City of El Paso – City Plan Commission Staff Report

Case No: SUSU13-00002 – Glenwood Circle Place
Application Type: Resubdivision Combination
CPC Hearing Date: May 30, 2013
Staff Planner: Nelson Ortiz, (915) 541-4931, ortiznx@elpasotexas.gov
Location: North of Border Highway and East of Glenwood
Acreage: 2.03 acres
Rep District: 8
Existing Use: Vacant
Existing Zoning: R-4 / SP (Residential/ Special Permit)
Proposed Zoning: R-4 / SP (Residential/ Special Permit)
Nearest Park: Ascarate Park (.181 mile)
Nearest School: Clardy Elementary School (0.391 mile)
Park Fees Required: \$24,660.00
Impact Fee Area: N/A
Property Owner: Mario Ornelas
Applicant: Aria Construction
Representative: Dorado Engineering, Inc.

ATTACHMENT 3

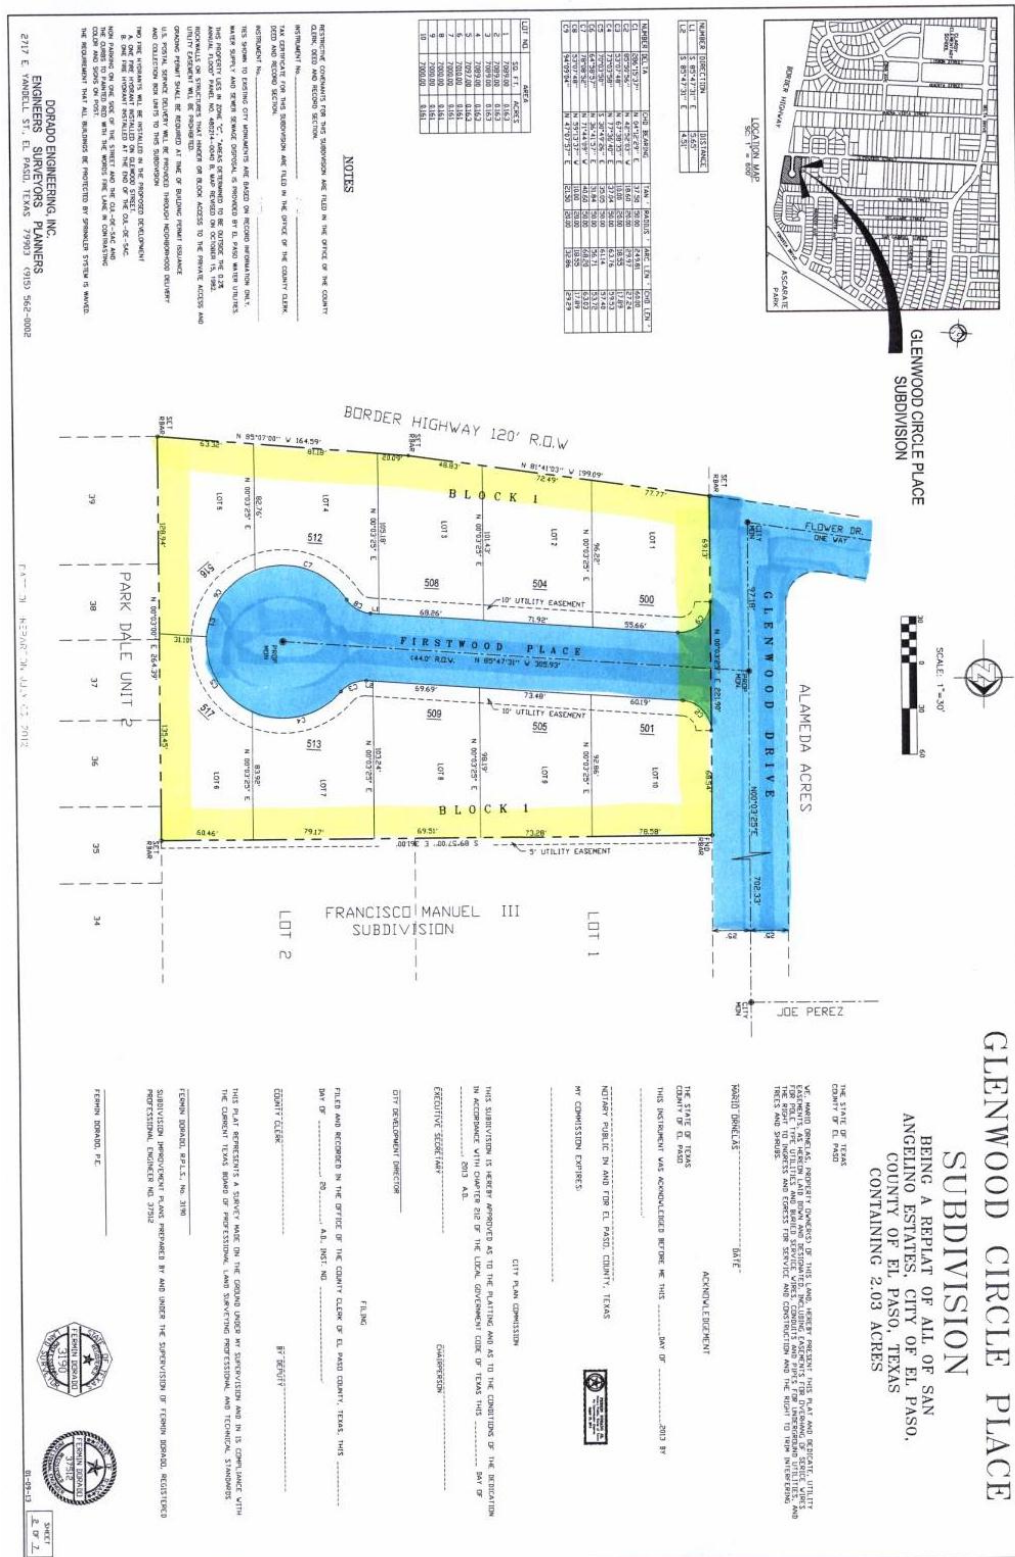
We have reviewed **Glenwood Circle Place**, a resubdivision combination plat map and offer Applicant / Developer / Engineer the following comments:

Please note that this subdivision is zoned "R-4" allowing the construction of Single-family & Two-family dwelling units, therefore, we offer the following comments:

This subdivision consists of 10 lots & Applicant is proposing 10 duplexes for a total of 20 dwelling units; per proposed number of units, this replat is increasing density as evidenced by the original subdivision and this replat therefore, subject to re-calculation of the "Park fees".

Applicant shall be required to pay "Park fees" in the amount of **\$24,660.00** based on the following calculations:

4. There is an existing 8-inch diameter water main along Glenwood Street. A water main extension along the proposed Dario Court is required. The Owner is responsible for all water main extension costs.
5. Previous water pressure reading from fire hydrant # 3118 located at the northwest intersection of Glenwood Street and Chesak Circle, have yielded a static pressure of 102 (psi) pounds per square inch, a residual pressure of 86 (psi) pounds per square inch and a discharge of 1163 (gpm) gallons per minute
6. The owner should, for his own protection and at his own expense, install at the discharge side of each water meter a pressure regulator, strainer and relief valve, to be set for pressure as desired by the customer. The Lot owner shall be responsible for the operation and maintenance of the above-described water pressure regulating device.

7. There is an existing 8-inch diameter sanitary sewer main along Glenwood Street. A sewer main extension along the proposed Dario Court is required. The Owner is responsible for all sewer main extension costs.

The name of the street in itself currently exists, therefore, even if connected to, and even if it has a different suffix, constitutes duplicity.

- The El Paso County 911 District **Requests** that another name be chosen for this street.
- The El Paso County 911 District requests that addressing is displayed on the plat for review while still in the preliminary stage.

(Comments have been addressed by applicant.)
